## Modification or Addition to Improvement Standards and Details

Modification Number: 20071231-1

**PEDESTRIAN PUSH BUTTON DETAIL**

DRAWING NUMBER  
**T - 19**

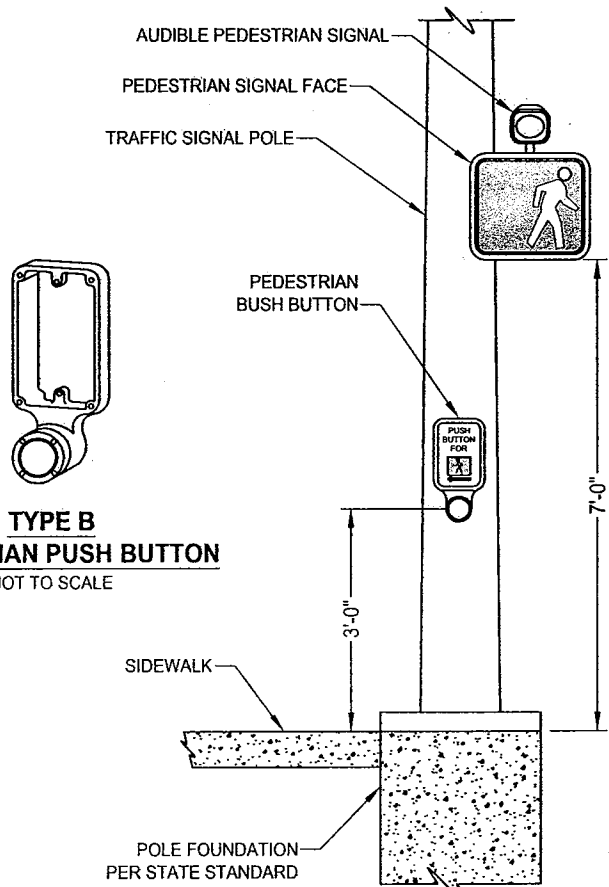
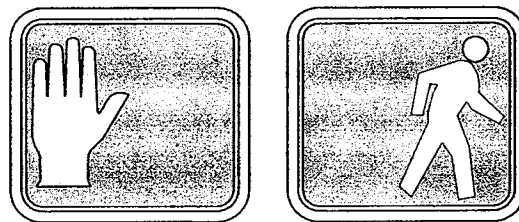
- Modification to T19:
  - Revised note 2 to specify pedestrian push button sign, R10-4b, per California MUTCD 2003 edition.
  - Added dimensions for the location of the 1B push button pole (6" behind back of crosswalk)

- This modification will ensure the proper sign and size of the pedestrian push button sign as specified in the MUTCD and California MUTCD 2003 edition.
- And to ensure that there is clearance between the edge of sign and the sidewalk.

1. PEDESTRIAN PUSH BUTTON SHALL BE TYPE B, LARGE A.D.A. TYPE WITH A TWO-INCH (2") DIAMETER BUTTON.
2. PEDESTRIAN SIGNS SHALL BE METAL AND SHALL CONFORM TO STANDARD SIGN NO. R10-4b OF THE MUTCD 2003 EDITION AND CALIFORNIA MUTCD EDITION.
3. PEDESTRIAN PUSH BUTTON HOUSING SHALL BE EITHER DIE-CAST OR PERMANENT MOLD CAST ALUMINUM.
4. AUDIBLE PEDESTRIAN SIGNAL SHALL BE MODEL APS-10 BY INDICATOR CONTROLS CORPORATION, OR APPROVED EQUAL.
5. ALL PEDESTRIAN SIGNAL HEADS SHALL BE THE "COUNTDOWN" VARIETY.
6. PEDESTRIAN HEADS SIGNAL DISPLAY SHALL BE HIGH INTENSITY L.E.D. AND MUST MEET THE STATE SPECIFICATIONS REQUIREMENTS FOR LUMINANCE. THE DISPLAY SHALL INCLUDE SOLID (FILLED IN) "WALKING PERSON" AND "RAISED HAND" SYMBOLS.
